FORM FOR COMMENT FOR 2014 NATIONAL ELECTRICAL CODE®

1. Section/Paragraph 705.12(D)(2)

2. Comment on Proposal No. (from ROP): 4-375a

Scenario 1:

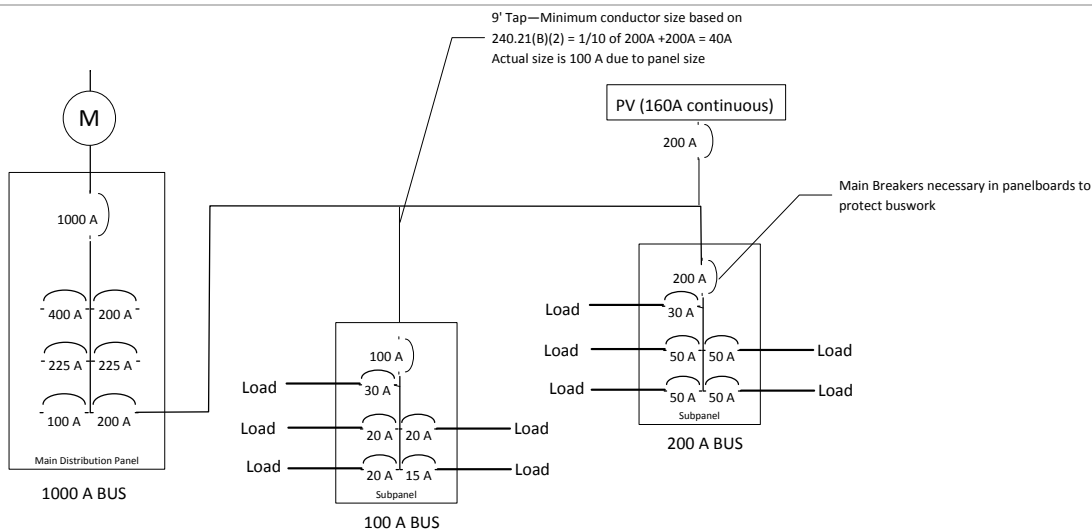
1. Largest allowable PV system on load side at the opposite end of the primary supply OCPD
2. 200-amp feeder
3. 9', 100-amp tap to 100-amp subpanel
4. Large PV at opposite end of feeder—requires 200-amp connection—size governed by inverter output
5. OKAY—Overcurrent protection covers all cases of overcurrent (tap prohibition not required)

Scenario 2:

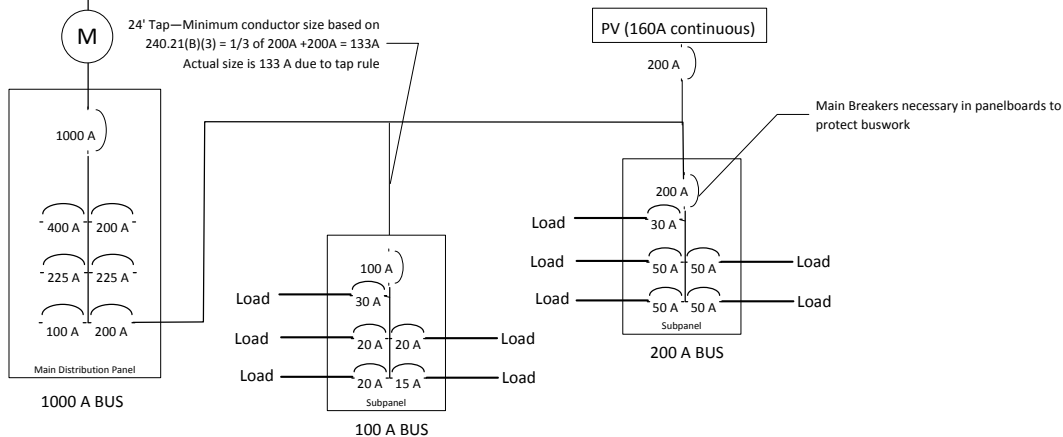
1. Largest allowable PV system on load side at the opposite end of the primary supply OCPD
2. 200-amp feeder
3. 24', 100-amp tap to 100-amp subpanel must be sized for 133A to meet tap rule.
4. Large PV at opposite end of feeder—requires 200-amp connection—size governed by inverter output
5. OKAY—Overcurrent protection covers all cases of overcurrent (tap prohibition not required)

Scenario 3:

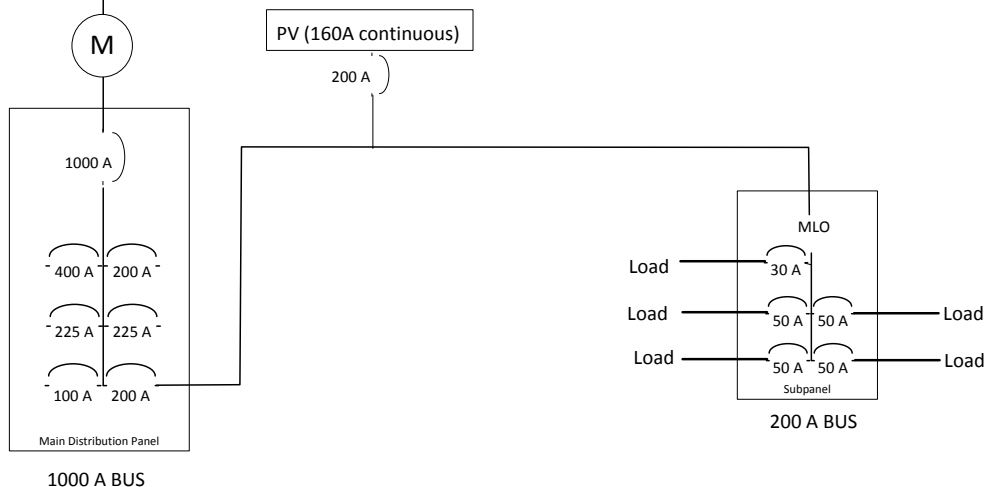
1. Largest allowable PV system on load side.
2. 200-amp feeder
3. Large PV requires 200-amp connection—size governed by inverter output
4. NOT OKAY since 200-amp feeder and panelboard bus could be overloaded

Scenario 4:

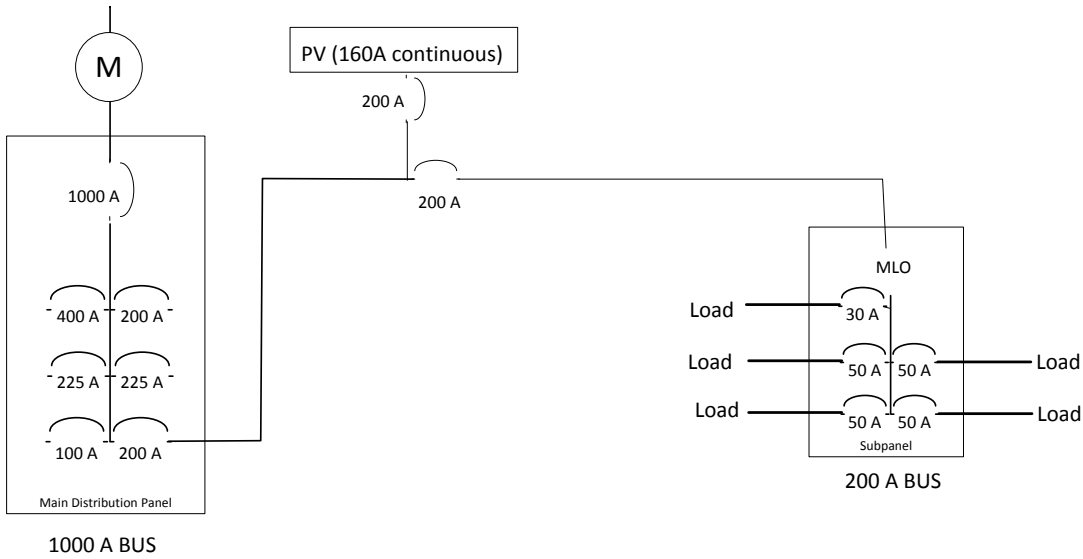
1. Largest allowable PV system on load side.
2. 200-amp feeder
3. Large PV requires 200-amp connection—size governed by inverter output
4. OKAY—Load-side section of feeder protected with OCPD

New Scenario 5:

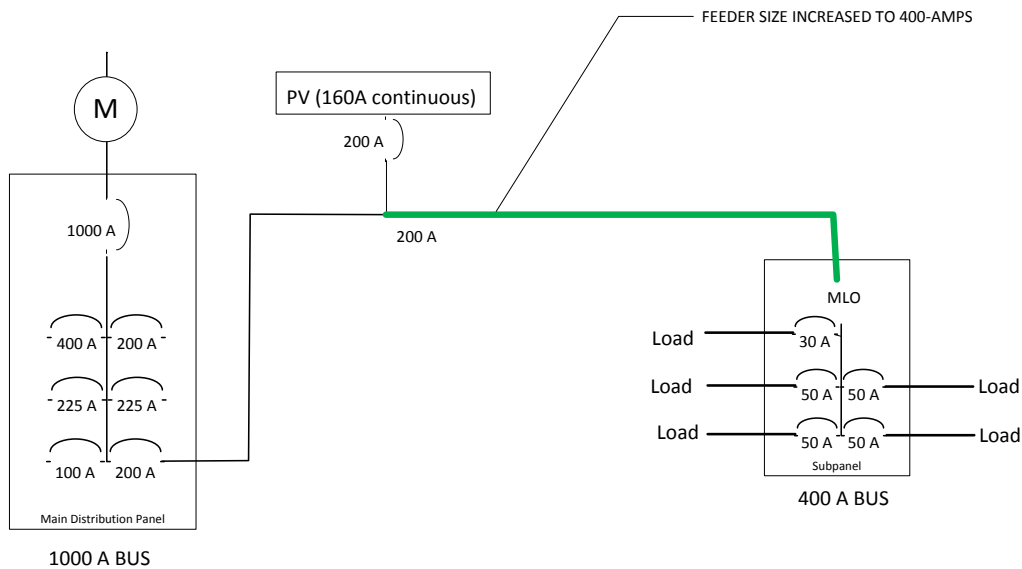
1. Largest allowable PV system on load side.
2. 200-amp feeder on supply side of U-I inverter, and 400-amp feeder and panelboard on load side
3. Large PV requires 200-amp connection—size governed by inverter output
4. OKAY—Load-side section of feeder sufficient for both currents
